Southern Nevada Amendments

International Residential Code

Published: October 12, 2006

### **FIGURE R606.11(1) ANCHORAGE REQUIREMENTS FOR MASONRY WALLS LOCATED IN SEISMIC DESIGN CATEGORY A, B OR C AND WHERE WIND LOADS ARE LESS THAN 30 PSF**

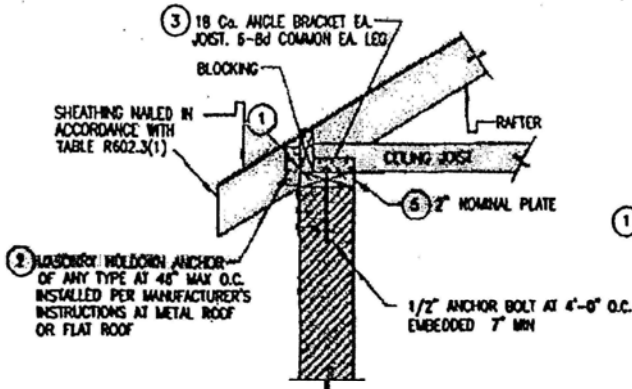
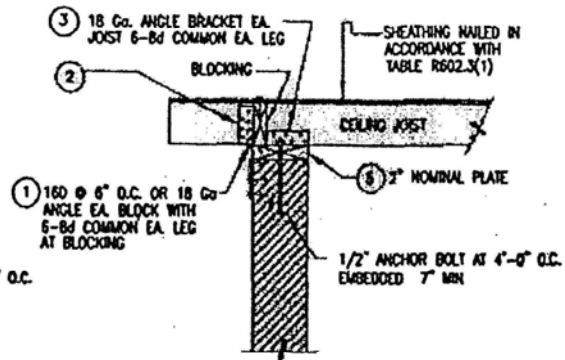
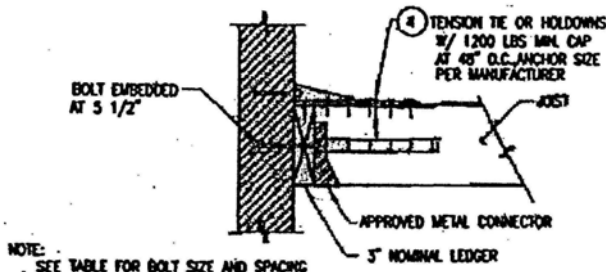
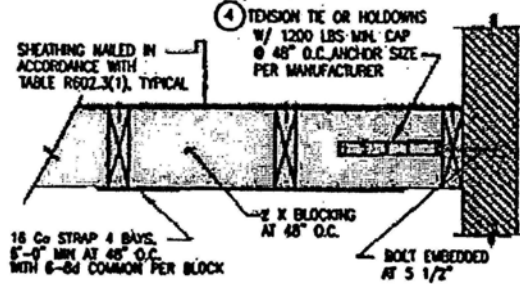
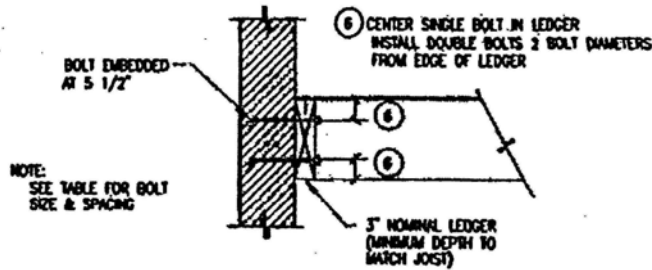
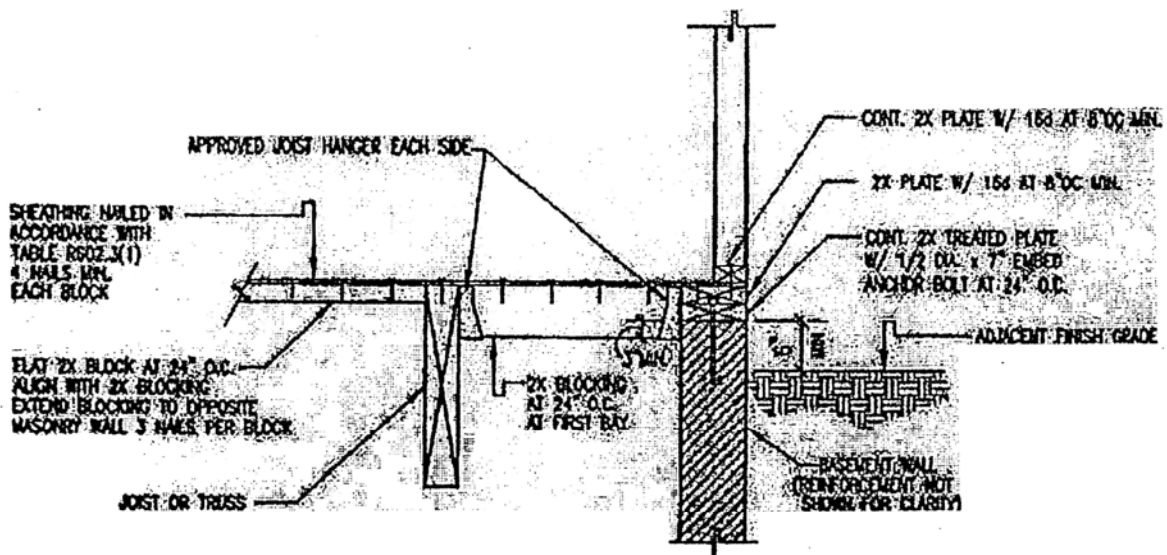
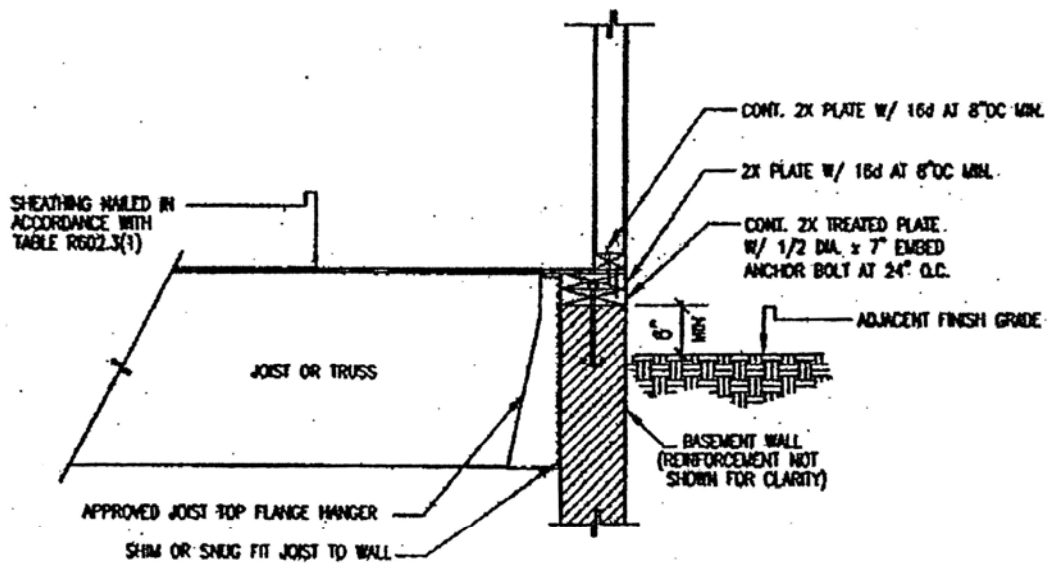
Figure R606.11(1) is deleted and replaced with a new Figure R606.11(1) to read as follows:

NOTE: SEE TABLE FOR BOLT SIZE AND SPACING

1. BOLTS SHALL BE INSTALLED WITH A METAL PLATE, METAL STRIP, OR WASHER NOT LESS THAN A STANDARD CUT WASHER BETWEEN THE WOOD AND THE BOLT HEAD AND BETWEEN THE WOOD AND THE NUT.

NOTE: WHERE BOLTS ARE LOCATED IN HOLLOW MASONRY, THE CELLS IN THE COURSES RECEIVING THE BOLT SHALL BE GROUTED SOLID.  
FOR S: 1 INCH = 25.4 MM, 1 FOOT = 304.8MM, 1 POUND PER SQUARE FOOT = 0.0479KPA/M<sup>2</sup>
